Norsk Hydro a.s

FILE NO: 61.07.22

WELL CRITIQUE - 30/7-5

Årsak til glipp på 20" Casing.

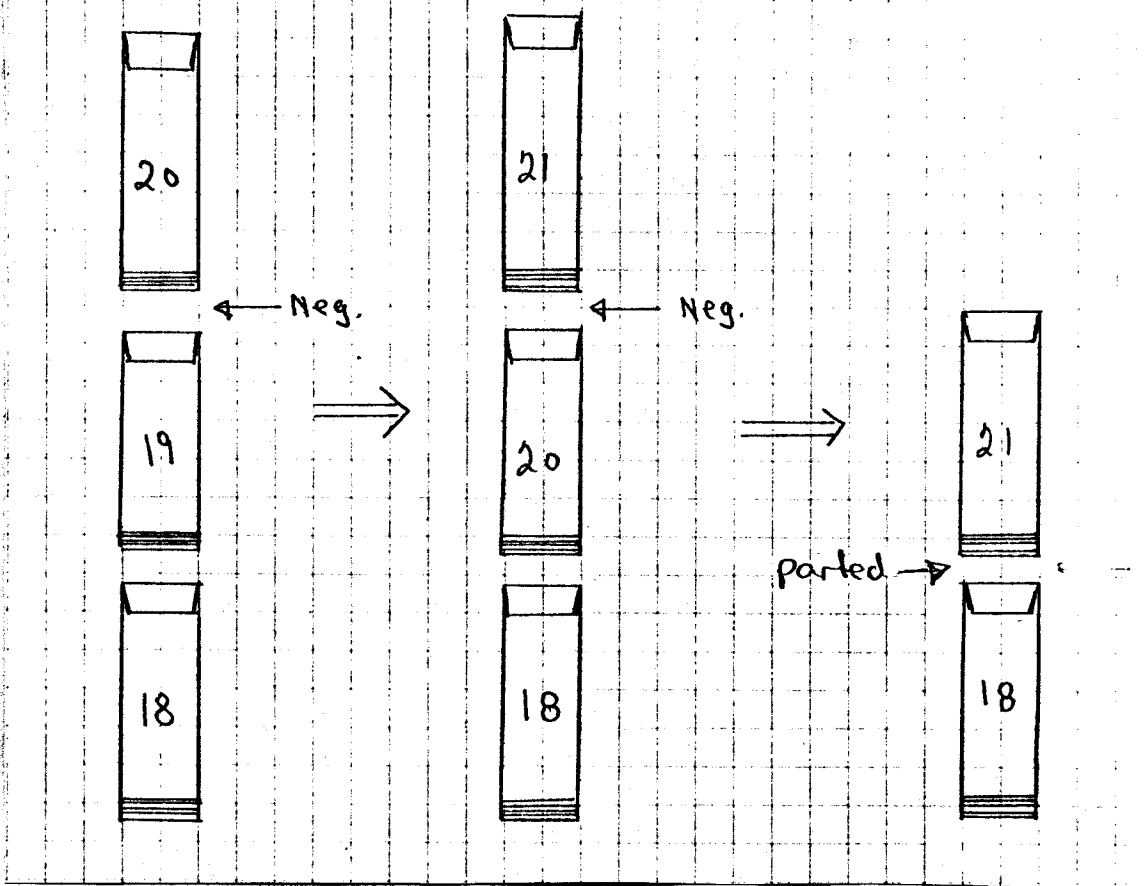
When joint No. 20 should be made up to No. 19 (see sketch), this was not possible due to oval box on No. 19. Joint No. 19 had therefore to be disconnected and joint No. 20 was made up to No. 18. When joint No. 21 should be made up to No. 20 the same happened, and joint No. 20 was disconnected. Joint No. 21 was then made up to No. 18. The casing job was continued problemfree until the casing parted while joint No. 33 was going to be made up to No. 32.

When pulling out of hole it was found that the string had parted between joints No. 18 and 21.

Skisse 1:

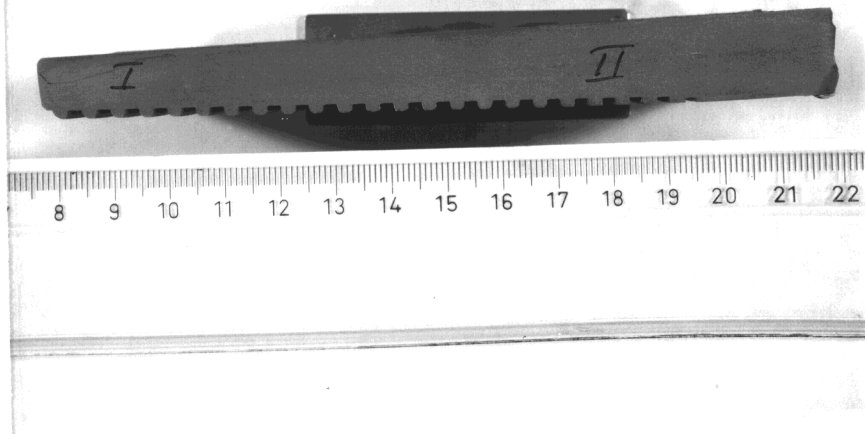
The measured angle of the cone on the pin,  $2.15^{\circ}$ , is less than what is accepted by SPI std. 5B, pkt. 3., which gives that the angle shall be between  $2.32^{\circ}$  and  $2.52^{\circ}$ .

1. Oppmålingen ble utført med mikrometer av folk fra vårt maskinverksted. Måleresultatene er vist på skisse 1.
  - Det ble funnet eksentrisitet i pinend på 0.9 mm nederst og 1.1 mm midt på gjengepartiet. P.g.a. stigning på gjengene, vil denne målingen være noe unøyaktig.
  - Åpningsvinkelen på konen til pinend og boxend er identiske. Beregning utfra måleverdiene viser følgende resultat:

$\alpha$  Pinend 2.15°  
 $\alpha$  Boxend 2.40°

Bilde 1: Snitt av gjengeparti fra Pin-end, 20" casing.

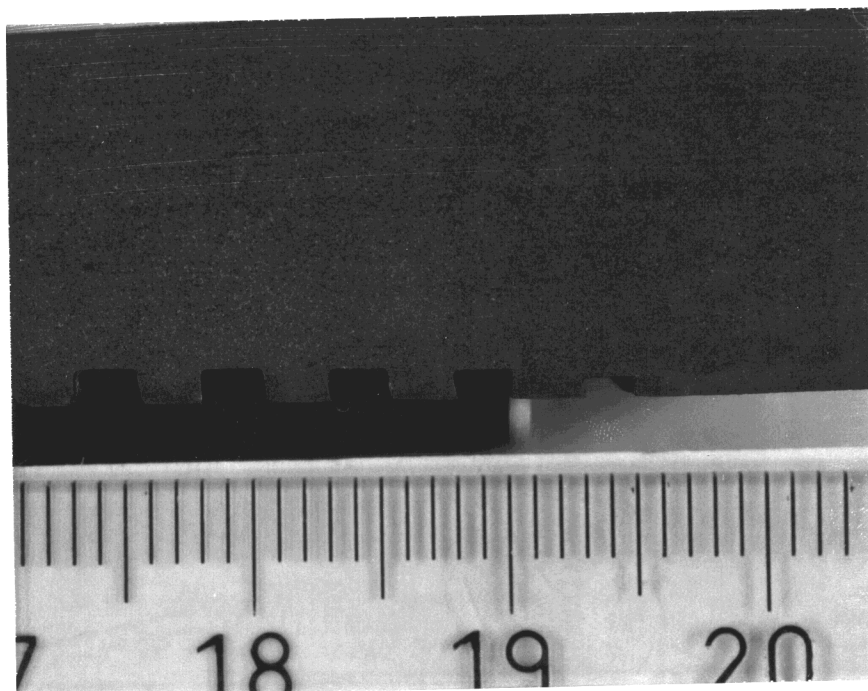
- c) Tannhøydene ble målt til 1.8 mm på pinend, og 2.00 mm på boxend.
2. Bilde 1 viser gjengepartiet fra pinend i snitt. Områdene II og I er vist forstørret i bilde 2, henholdsvis bilde 3. Gjengene i område I viser tildels sterk deformasjon, spesielt i underkant av gjengen. Denne deformasjon er ikke registrert i område II (bilde 2). Her synes gjengene ubeskadiget. Et bilde av gjengenes overflatebeskaffenhet er vist i bilde 4. Det opptrer riper på hver eneste gjenge frem til område II. Her slutter ripene, slik at de siste 5 gjengene er fri for disse skadene.
  3. Mikrofoto (bilde 5) viser tydelig flytelinjer etter deformasjon. Bunnen av gjengene viser ikke denne type skader.
  4. En karbonanalyse av materialet ga følgende resultat:

Bilde 3: Snitt av gjengeparti I (bilde 1) med synlig deformasjon av gjengene.

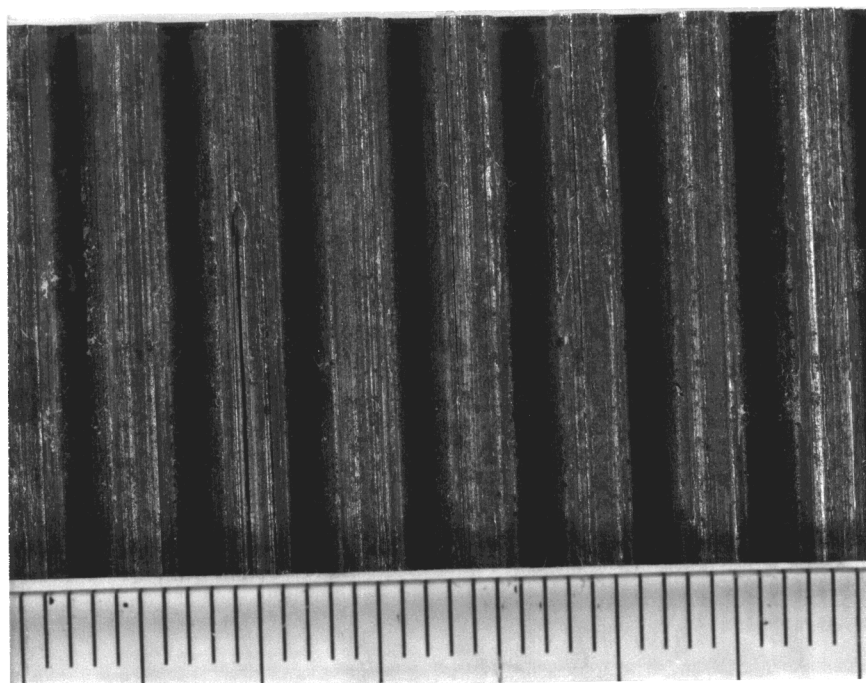
- Differensen i gjengehøyde og det faktum at gjengebunnen ikke var synlig deformert, sammen med de sterke deformasjonene på gjengene, tyder på at disse ikke har vært i ingrep. Dette er den mest sannsynlige grunnen til at gjengeforbindelsen glapp.
- Eksentrisiteten på pinend kan ha vanskeliggjort entringen av gjengene.
